# REDTAIL RANCH FILING NO. 1

A REPLAT OF LOTS 1 AND 2, WALKER PLACE, TOGETHER WITH A PORTION OF SECTION 9, TOWNSHIP 12 SOUTH, RANGE 65 WEST OF THE SIXTH PRINCIPAL MERIDIAN, EL PASO COUNTY, COLORADO

REDTAIL RANCH FILING NO. 1  
2525.00  
MARCH 13, 2018  
SHEET 1 OF 3

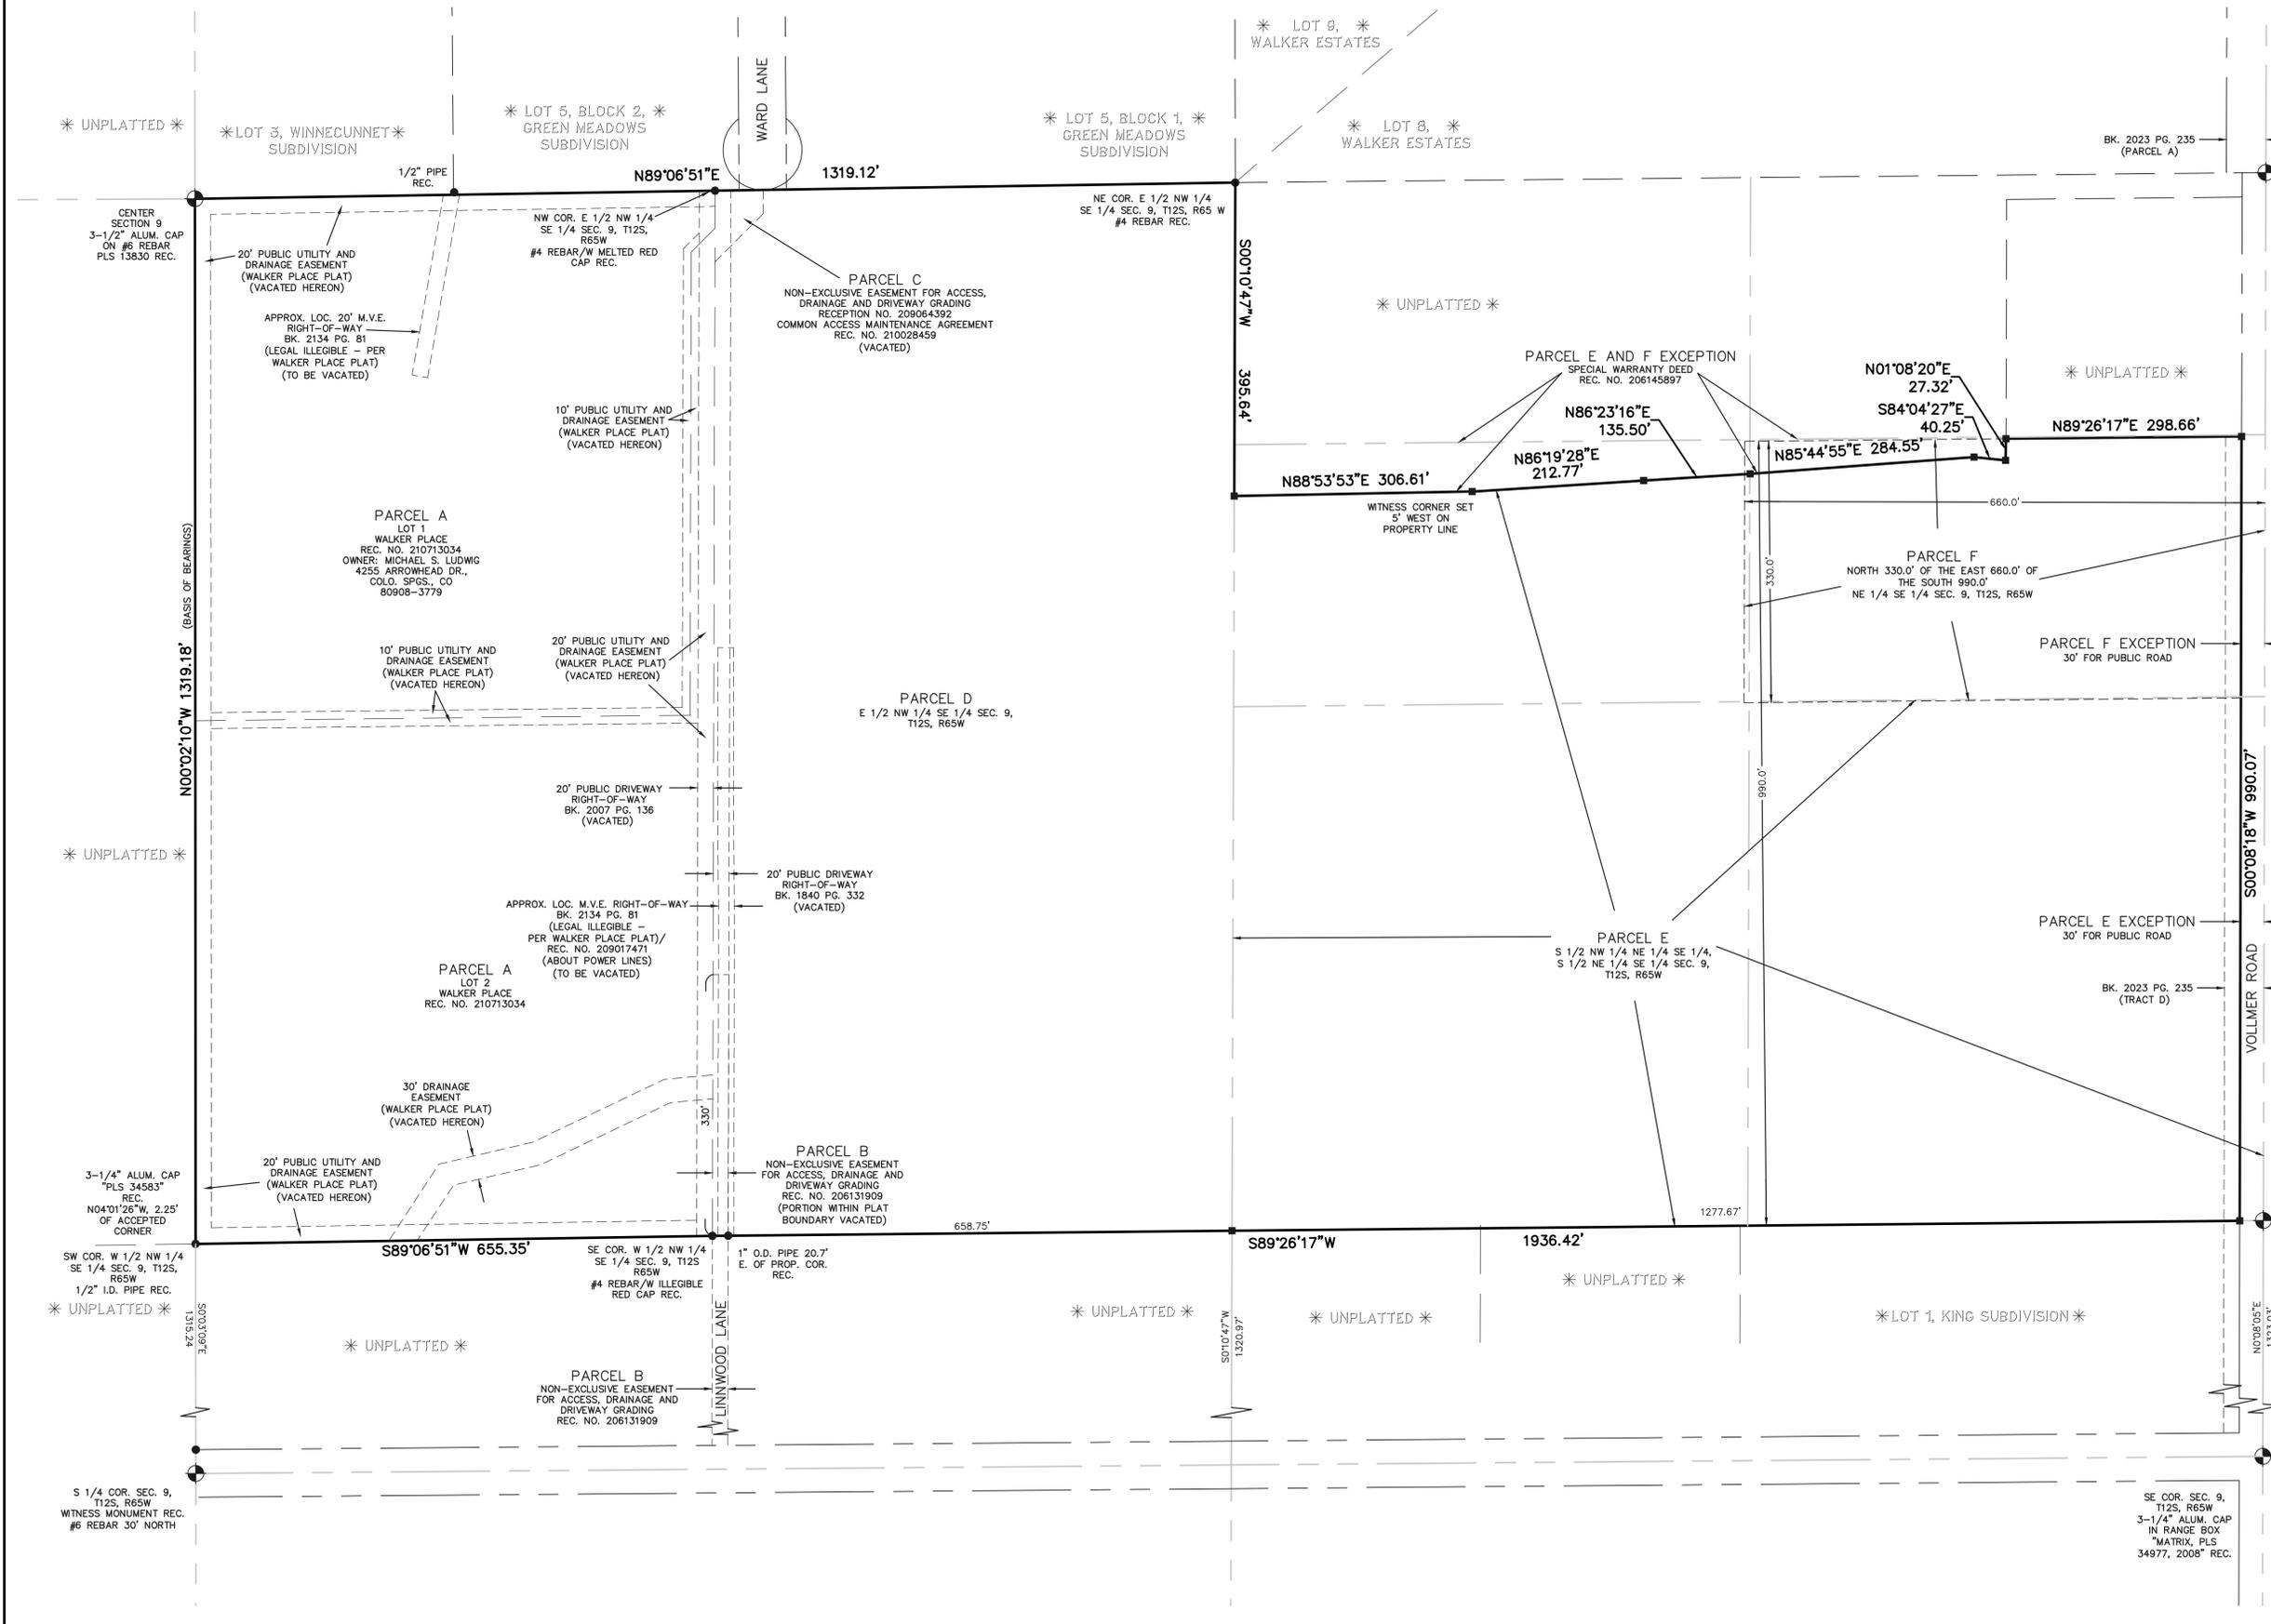
Geo Constraint note please add

Add reports are available in the preliminary plan (SP-18-004) file at the Planning and Community Development Department.

If yes going into a PID add the additional PID note please if NOT disregard.

Assessor signature only necessary IF subdivision is going into a PID

DRAINAGE: \_\_\_\_\_ Please add basin name and basin NO.  
BRIDGE FEES: \_\_\_\_\_  
URBAN PARK: \_\_\_\_\_  
REGIONAL PARK: \_\_\_\_\_  
SCHOOL FEE: \_\_\_\_\_  
SURCHARGE: \_\_\_\_\_  
FEE:  Delete FEE

REDTAIL RANCH FILING NO. 1  
2525.00  
MARCH 13, 2018  
SHEET 3 OF 3

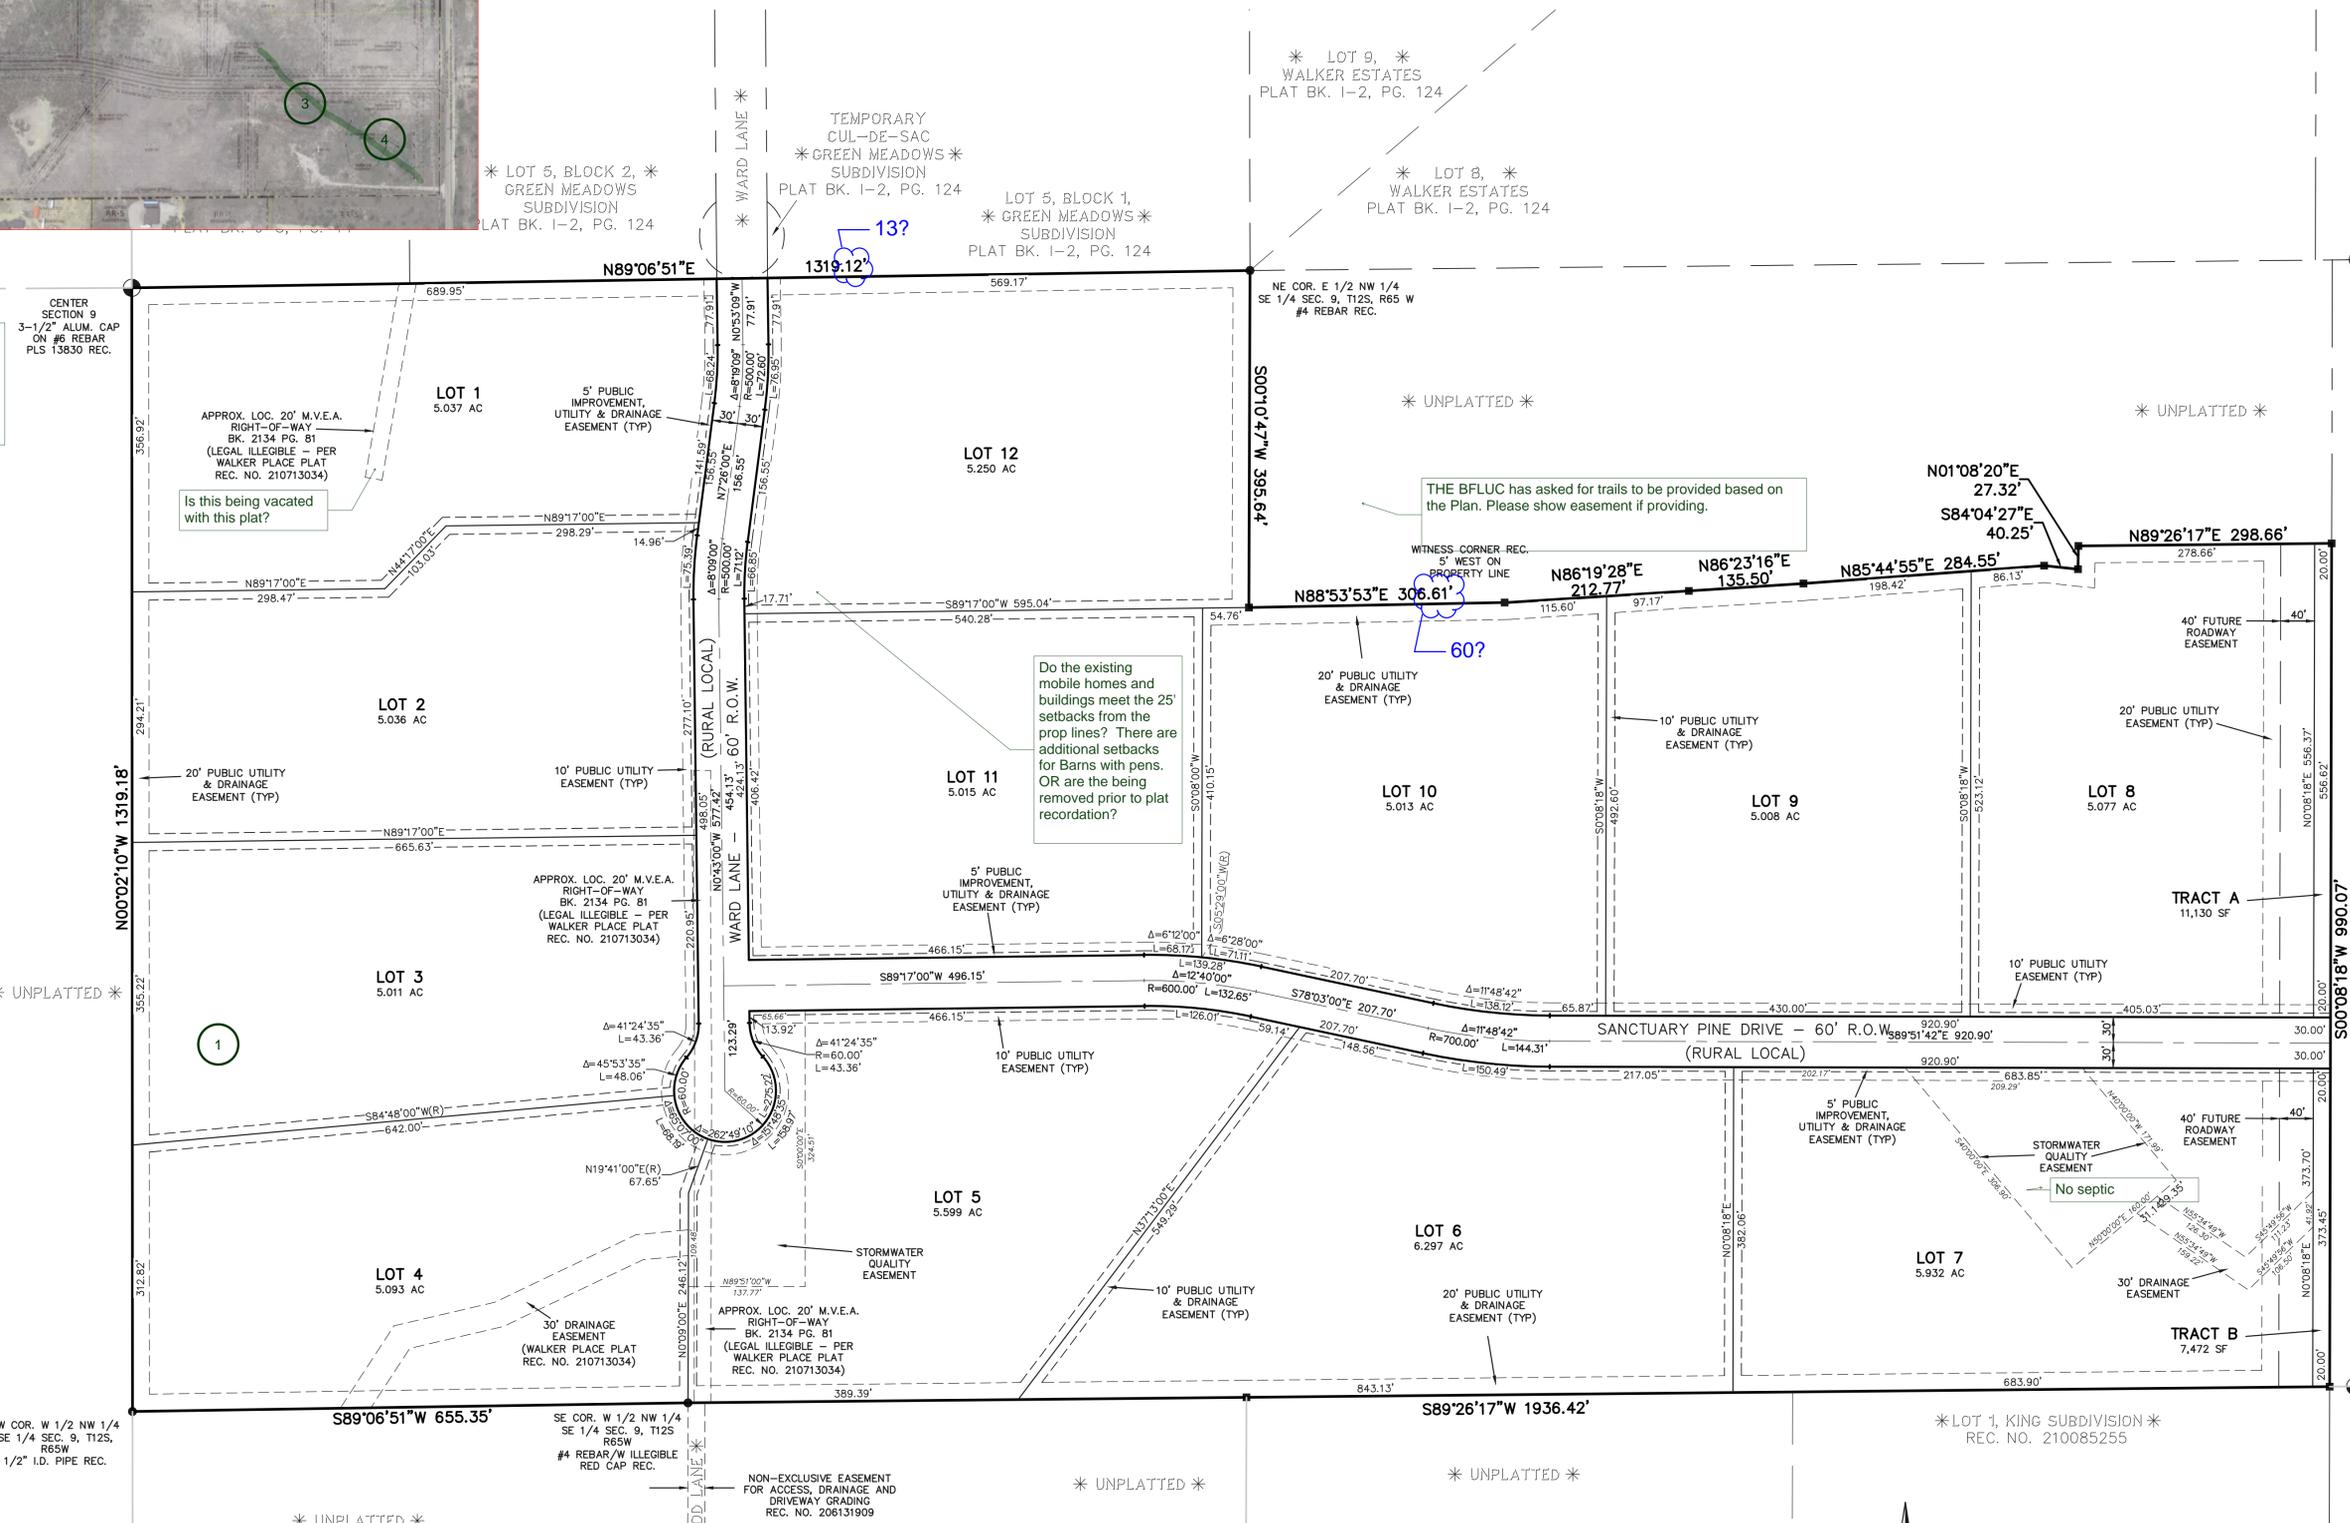
1  
There are existing  
ponds and drainage  
ways that should be  
in easements if they  
are to remain and no  
build areas, no septic  
areas.

Do the existing  
mobile homes and  
buildings meet the 25'  
setbacks from the  
prop lines? There are  
additional setbacks  
for Barns with pens.  
OR are the being  
removed prior to plat  
recording?

THE BFLUC has asked for trails to be provided based on  
the Plan. Please show easement if providing.
